PRODUCT BULLETIN # 16967

Issue Date: 24-Jan-2013

TITLE: SPI EEPROM Products Timing Exception

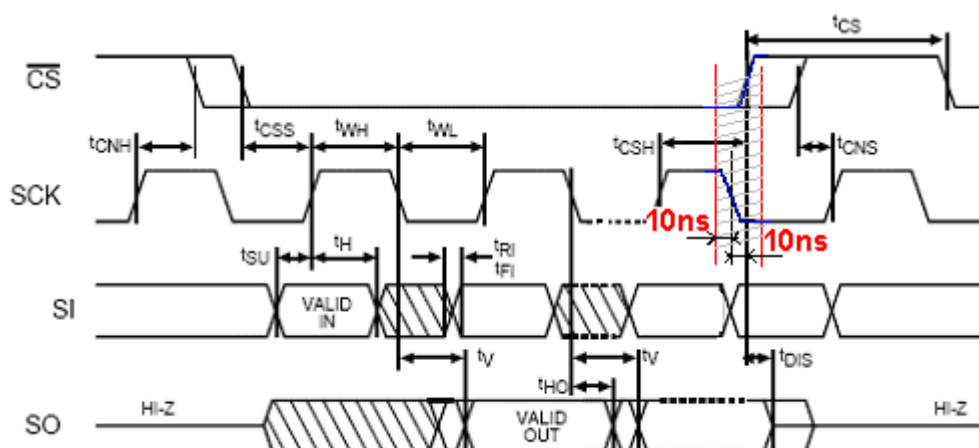
The timing exception refers to the t_{CSH} parameter in the context of the WREN instruction, where t_{CSH} is the delay from the positive Clock (SCK) transition to the positive CS transition (as shown below). The WREN instruction will not be executed (i.e. Write will not be enabled) – if the positive CS transition occurs within fewer than 10 ns either before or after the negative SCK transition:

Since this timing exception does not apply to OKI sourced parts, users switching from OKI to Gresham are urged to validate application compatibility – before deploying Gresham parts into production.
